Access Compliance Report

Public Rights-of-Way

(Curb Ramps)

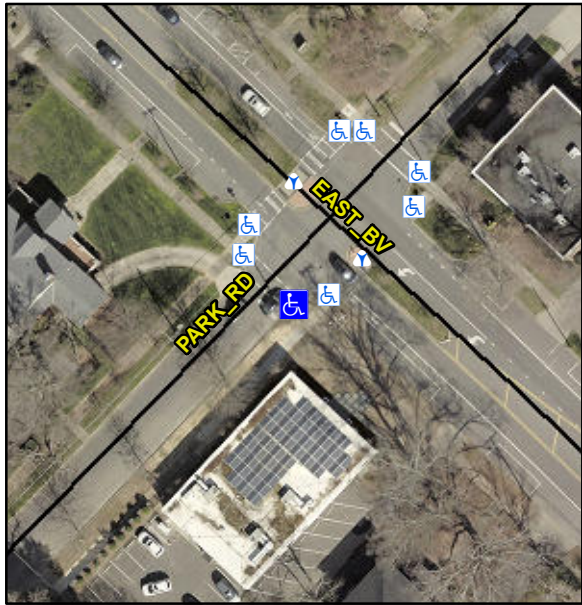
Intersection ID: 14741		Main Street: EAST_BV		Cross Street: PARK_RD		Location: SW											
ADA ID: A1A3D84CB0AC		Ramp Type: Directional1		Initial Pass/Fail: Fail		Overall Compliance: No		Severity Score: 1.25									
Codes/Mitigation Info/Possible Solution				Field Measurements/Component Compliance													
<div></div> <div>Possible Solutions:</div> <div>Remove & Replace Entire Ramp.</div> <div>Surveyor Notes:</div> <div>N/A</div> <div>PROW/ADA:</div> <div>R304.5.3</div> <div>Street 1 NamePARK RD</div> <div>Stop Condition-Street 1StopSign</div> <div>Street 2 NameN/A</div> <div>Stop Condition-Street 2N/A</div> <div>Total Cost:\$1600.00</div>				Compliance		Description		Data		Compliance		Description		Data			
				N/A		Ramp Length (in)		70.0		N/A		Grade Break?		N/A		N/A	
				Yes		Ramp Width (in)		73.0		N/A		Grade Break Slope (%)		N/A		0.0	
				Yes		Ramp Slope (%)		4.3		N/A		Grade Break XSlope (%)		N/A		0.0

No		Ramp XSlope (%)		2.9									
				N/A		Flare Type LT		N/A		N/A		Flare Type RT		N/A		N/A	
				N/A		Flare Slope LT (%)		N/A		N/A		Flare Slope RT (%)		N/A		0.0	
				N/A		Flare Traversable LT?		N/A		N/A		Flare Traversable RT?		N/A		N/A	
				N/A		Landing Length (in)		0.0		N/A		DWS Provided?		N/A		N/A	
				N/A		Landing Width (in)		0.0		N/A		DWS Contrast?		N/A		N/A	
				N/A		Landing Slope (%)		0.0		N/A		DWS Length (in)		N/A		N/A	
				N/A		Landing X Slope (%)		0.0		N/A		DWS Full Width?		N/A		N/A	
				N/A		Landing Curb? (Y/N)		N/A		N/A		DWS Offset LT (in)		N/A		N/A	
				N/A		Shared Landing?		N/A		N/A		DWS Offset RT (in)		N/A		N/A	
				N/A		Gutter Ponding?		0.0		N/A		Gutter Slope (%)		N/A		N/A	
				N/A		Gutter Lip Ht (in)		0.0		N/A		Gutter X Slope (%)		N/A		N/A	
				N/A		Painted X Walk1?		Yes				Road Slope (%)		N/A		2.8	
						X Walk 1 Direction		To NW				Road X Slope (%)		N/A		1.9	
						X Walk 1 Width (in)		112.0				Clear Space?		N/A		N/A

X Walk 1 Slope (%)		2.8		N/A		Clear Space to XWalk (in)		N/A		N/A	
						X Walk 1 X Slope (%)		1.9		N/A		Storm Grate/Utility Hazard?		N/A		N/A	
				N/A		Ramp inside XWalk1?		Yes				Storm Grate/Utility Type					
				N/A		Any Obstructions?		N/A						N/A		N/A	
						Obstruction Type				Yes		Surface Condition? (G/P)		Good		Good	
										N/A		N/A		Curb Slope (%)		9.0
